RESPONSE TO REVIEW

This manuscript presents an analysis of cross-sectional deformations in wind turbine blades under operational conditions and their impact on aerodynamic loads. The added value of this work is to quantify the aero-structural couplings where the structural cross-sectional deformations impact the airfoil shape, which in turn affects the aerodynamic loads. This field of study is relevant for the wind energy community due to the increase in blade flexibility. Furthermore, quantifying couplings is particularly important for multi-disciplinary design optimization of wind turbines.

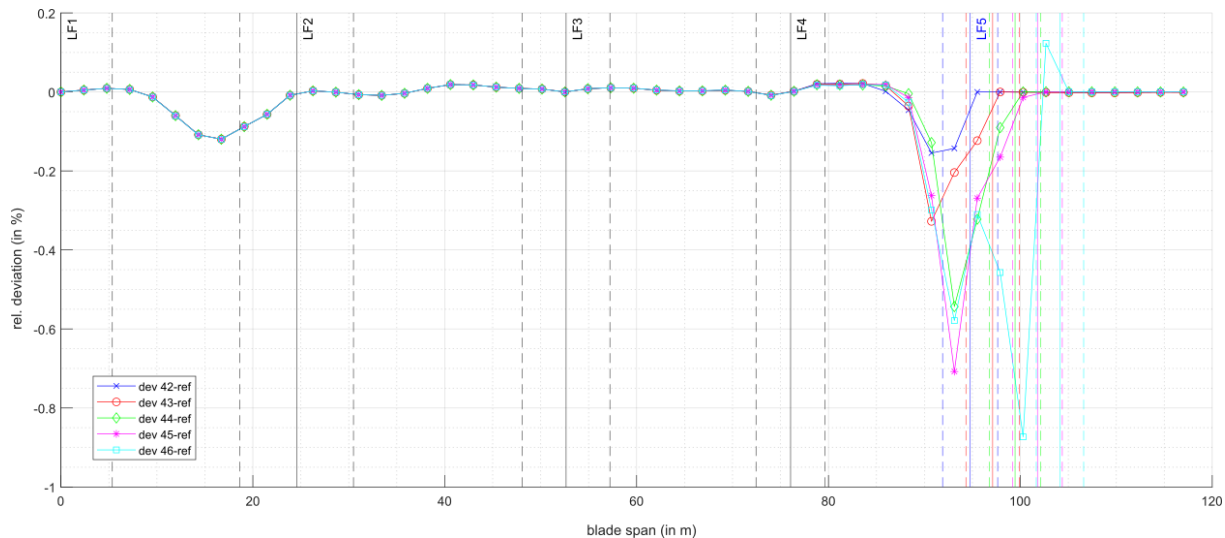
- I.163 "The loads were applied via multi point constraints that represented a load introduction similar to load frames". Please justify this model choice and its impact on the results of the study. Why simulate a blade-testing environment and not an operational environment, i.e. loads continuously distributed along the blade? This is particularly important considering the results of Figure 11. It seems that the high deviation observed at the location $r/R = 0.8$ is due to the presence of a load frame.

There are various approaches for load application in FE rotor blade models. Can et al. (2020) apply the extreme loads at the nodes of the spar cap of the pressure and suctions side along the blade. Haselbach et al. (2015) apply the loads to a master node in the middle of the spar caps with coupling constraints to the other nodes of the spar caps. Our approach is to use loads that are concentrated in the longitudinal direction but distributed across the cross-section. All approaches have in common that they approximate the continuous bending moment distribution along the blade. Our approach was validated in comparison with a full-scale blade test, see Noever-Castelos et al. (2021), where the load introduction is comparable to our load frame-like modelling approach. However, the bending moments are approximated quite well, and thus it is assumed that the Brazier effect is approximated good enough. Since in the postprocessing evaluation we only consider regions that are unaffected by the load introduction, the methodology seems reasonable. We would like to emphasise that every modelling approach comes with the risk of boundary condition effects. In our case we at least ensure a reasonable distance to load introduction points to not provoke local effects.

For carried out additional analyses considering the load frame no. 5 (LF5), where we moved the position of LF5 towards the blade tip to investigate the cross-sectional deformation close to that load frame. The following figure shows the relative deviation of the chord length over the blade span.

The blade root (here LF1) is fully clamped. Load frames 2 – 4 are fixed for all simulations. We changed load frame 5 over 5 different positions. It can be seen that the peak between 90–95 m blade span occurs for all 5 load frame positions. The magnitude of the peak changes, however.
